**324 N. Main Street, Davenport IA – Partial Collapse  
Preliminary Investigative Report**

LF232566 / WBG202306  
August 15, 2023

Mr. Thomas Warner  
Corporation Counsel  
City of Davenport  
1200 East 46th Street  
Davenport, IA 52807

**White Birch Group, LLC**

**Fig. 15. Photograph from May 26, 2023 at approximately 3pm. Annotation by WBG and SEI.**

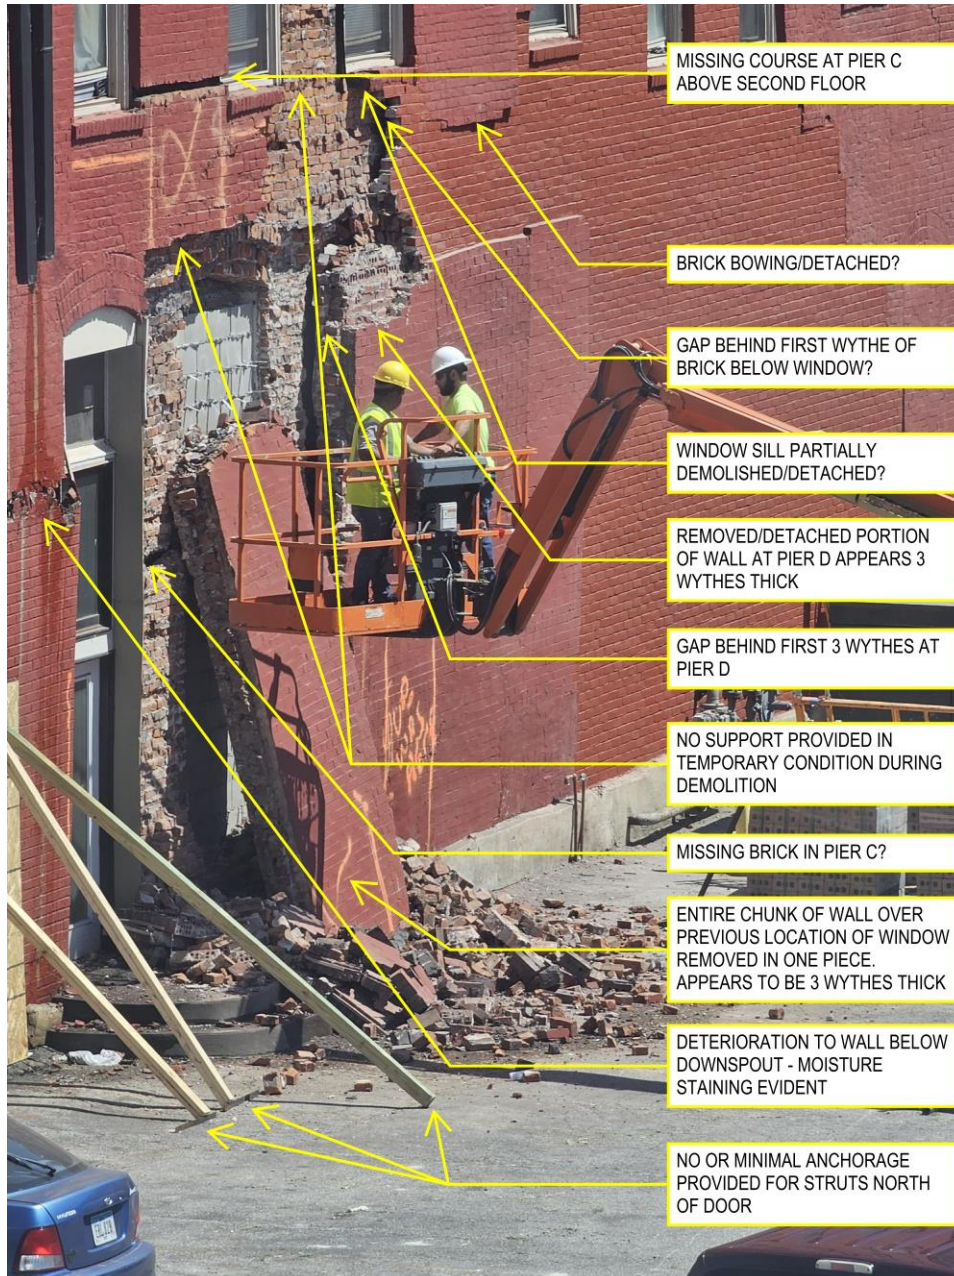
On May 26, 2023 (two days prior to collapse), a photograph was taken of the ongoing repair work at the building. An annotated version of this image is provided in **Fig. 15**. The image indicates several areas of nonconformance with the repair specifications issued by SSE, in addition to other deficient conditions.

**Fig. 25. Configuration of wall resulting from early 2023 repair project**

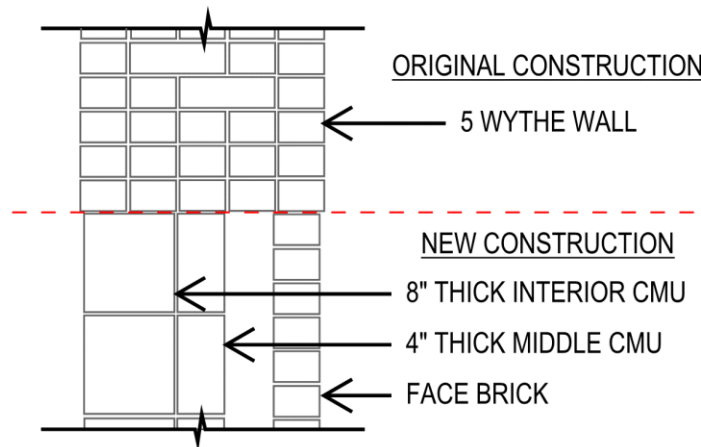
The new wall construction generally consisted of two wythes of CMU, a cavity, and a single wythe brick masonry veneer (see **Fig. 25**). Unlike the composite multi-wythe masonry of the floors above, the wythes in the new construction were not laterally tied together with headers or other shear ties to form a composite wall construction. Although corrugated steel veneer anchors were installed in some of the new CMU, these ties are typically designed only to provide lateral support for a veneer, not to engage the backup wall compositely through shear. Regardless, these ties were not engaging the exterior wythe of brick masonry (**Photograph 20**).

Further, since the new CMU wall construction did not provide continuous bearing support for all 5 wythes of the masonry bearing wall above, and left one of the intermediate wythes vastly unsupported (**Photograph 18** and **Photograph 19**) some of the unsupported brick masonry above became disengaged, and the loose brick fell and collected at the base of the first-floor wall cavity between the CMU backup and the outer brick veneer. This condition exacerbated the wall distress by exerting additional forces on the brick veneer. The accumulation of loose masonry was reported by SSE in their Addendum letter dated February 28, 2023 (**Photograph 21**).

Fig. 34. Figure 1 from SSE’s February 8, 2023 letter indicating the area of specified repair.

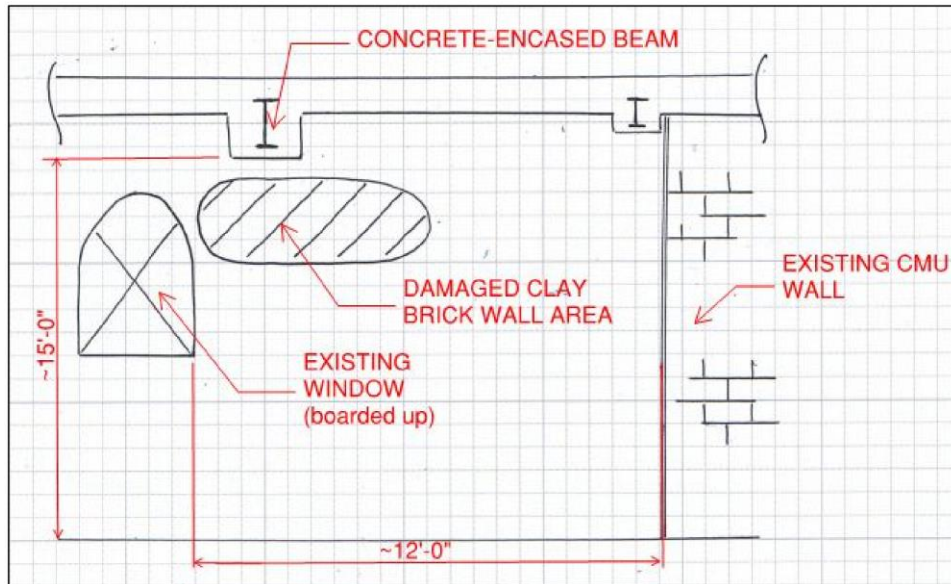
Figure 1 from the letter (included as **Fig. 34** in this report) indicates the extents of the observed distress (and therefore area of repair) as viewed from inside the building.

**Fig. 36. Figure 8 from SSE's February 8, 2023 showing needle beams and angles.**

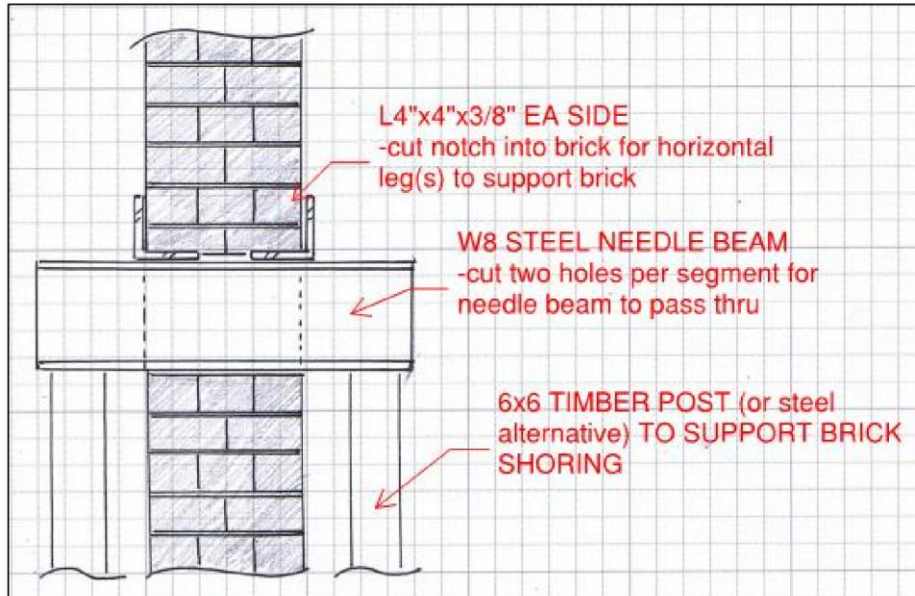
Further, SSE's "Figure 8" contained within the February 8, 2023 (**Appendix A: Fig. 36**), letter delineates a 3-wythe masonry wall, instead of the 5-wythe wall that existed. Although no scale is indicated, the dimensions assigned to the shoring elements contained in the drawing suggest a total wall thickness of approximately 12 in. and the original SSE replacement design only specified a single wythe of CMU replacement to support the 5-wythe wall.

This would result in over 12 in. (3-wythes) of unsupported brick masonry above the new CMU. The February 28, 2023, "Addendum" letter from SSE references a site observation by the masonry contractor that resulted in a modification of the original inadequate scope, changing the original installation of a single wythe of CMU to two wythes of CMU. However, the modified scope (**Appendix A: Fig. 38**) still results in more than 5 in. of unsupported wall thickness, and an overall weaker non-composite system.

Figure 8 of SSE's February 8, 2023 letter (included as **Fig. 36** in this report) shows a section through the wall. The wall was drawn as 3 wythes thick (rather than the 5 indicated on the original drawings), with steel angles supporting only the innermost and outermost wythes.

**Fig. 37. SSE shoring sketch dated February 9, 2023.**

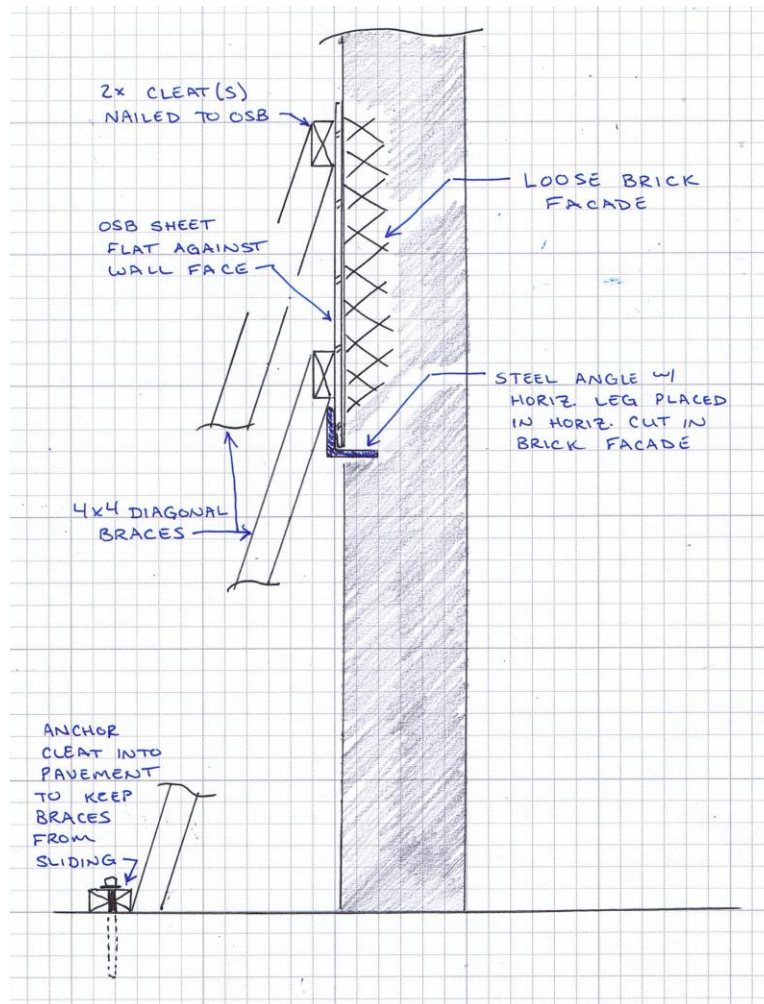
Two photographs were attached to the end of the report. Neither photograph displayed the exterior of the building. No plans or drawings were provided to locate the beams, and no specification was provided for the shoring to be installed.

**Photograph 21: Image from SSE February 28 Addendum letter.**

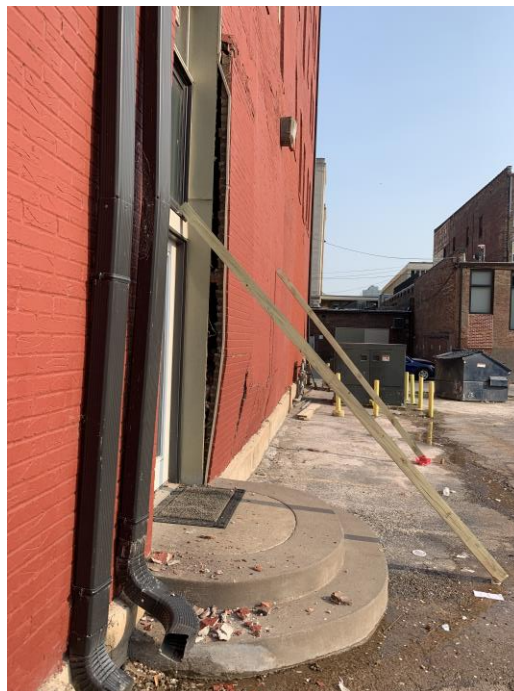
Note cavity between CMU wall and exterior wythes, and unsupported upper wythes of masonry.

**Photograph 27: Image from City file 23-30329.**  
Note mis-aligned masonry at Pier E brick replacement locations.

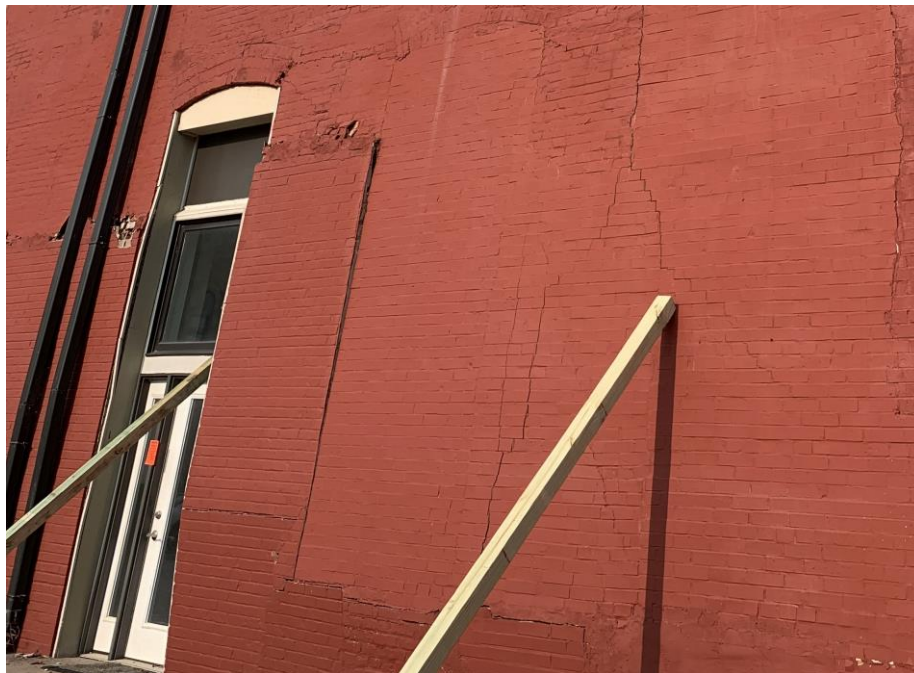
Further, many of the areas comprising previous repairs are not aligned/in-plane with the parent (existing) masonry wall (**Photograph 27**). This creates a lack of continuity, eccentric load path, and reduced capacity to support and transfer loads through the wall system.
